## Proposal: Approval of details reserved by Condition 4 of Planning Permission 23/00720/FULHH - Provision of 3 off-street parking spaces.

Site: 2 South View, Burrough on the Hill, Leicestershire, LE14 2JJ

Applicant: Mr Jack Beddall Melton Borough Council

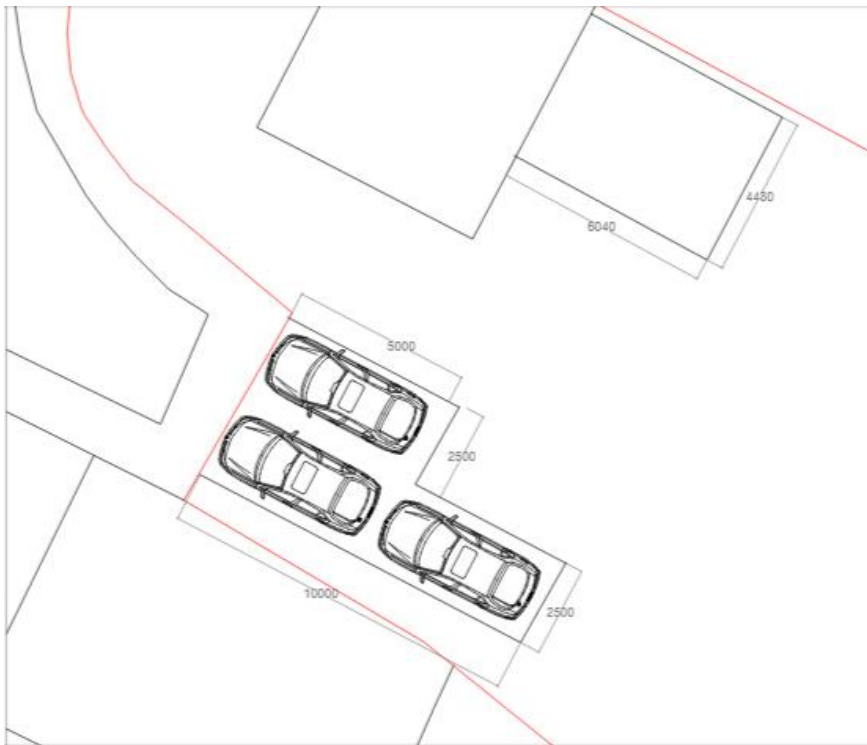
- e) I believe this style of tandem parking in this specific area, to be entirely ridiculous and would not serve people well by moving cars on a very narrow highway.

- f) The Parish Council's comments are very strong, and I agree with a lot what they are stating.
- g) It appears there is not enough thought gone into the application as aligned with the Design Supplementary Planning Document. It appears this has not paid any reference to the SPD which discourages tandem parking, but to have three is inappropriate.

- h) The SPD states "Don't include tandem parking". This would really encourage on-street parking and is inappropriate by design and fails to meet policy (D1) of the MLP.

- a) The proposal is contrary to both of these policies, MLP Policy IN2 and Somerby Neighbourhood Plan Policy TI1. 'Tandem' parking is usually discouraged and this 'tandem plus one' arrangement of three cars is a wholly bad design.

- b) The regular shuffling of the three vehicles in forward and reverse gear would be unsafe and adversely affect the amenity of other residents of the cul-de-sac. This brings the proposal into further conflict with policy IN2 as it would 'unacceptably impact on the safety and movement of traffic'.

- 8.1.2 A revised plan (reference: R3537-003 rev A) was submitted on the 23 July 2024 which illustrates x3 mixed on plot parking spaces to the south of 2 South View. The original plan that was submitted with the application illustrated x3 tandem parking spaces. This was

viewed as unacceptable and therefore a revised plan was submitted illustrating x2 parking spaces side by side with one additional space behind. This mixed plot arrangement is supported in the Design for Developments SPD. No change to the location of the parking area is proposed.

- 8.1.3 The parking spaces provided are considered acceptable as they would meet with the Leicestershire Highway Design Guide. It states that the minimum acceptable dimensions for a car parking spaces are 5m in length by 2.4m in width. The revised plan (ref: R3537-003 rev A) illustrates that the overall dimensions of the proposed spaces of 5m x 2.5m would meet the LHA's parking requirements.

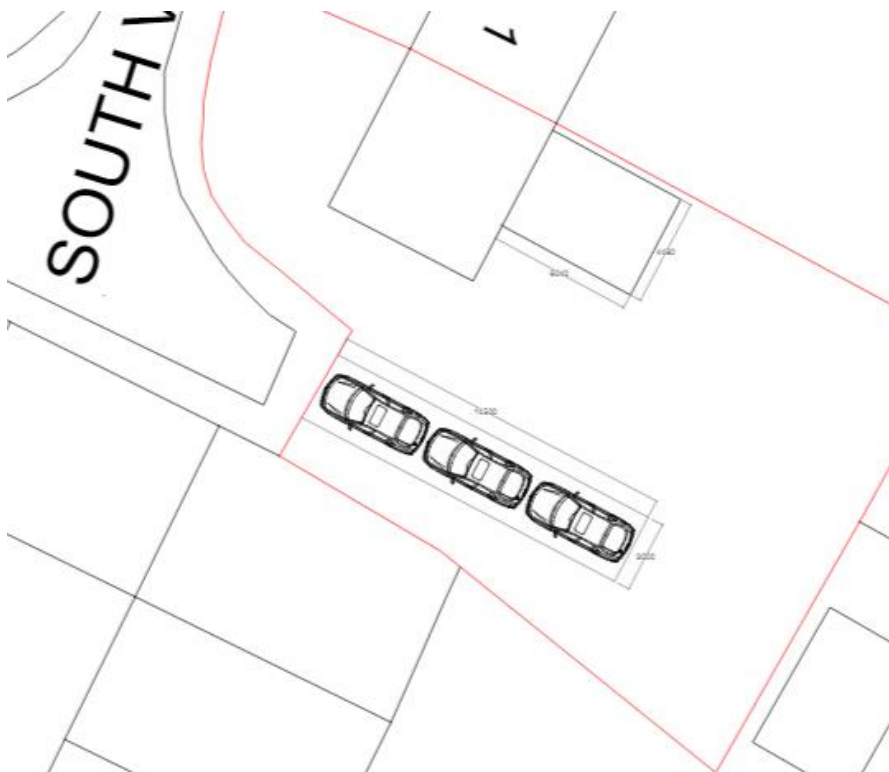
- 5.1 The application originally consisted of three parking spaces laid out in a tandem arrangement, shown on the plan below. Following consultation with the Parish Council and the Ward Councillor, Cllr. Higgins, the scheme has been amended to provide a mixed layout including two side by side parking spaces are provided adjacent to the highway boundary, with a single additional space behind. The proposed parking layout is considered to represent a betterment to the existing informal on-site parking arrangement.
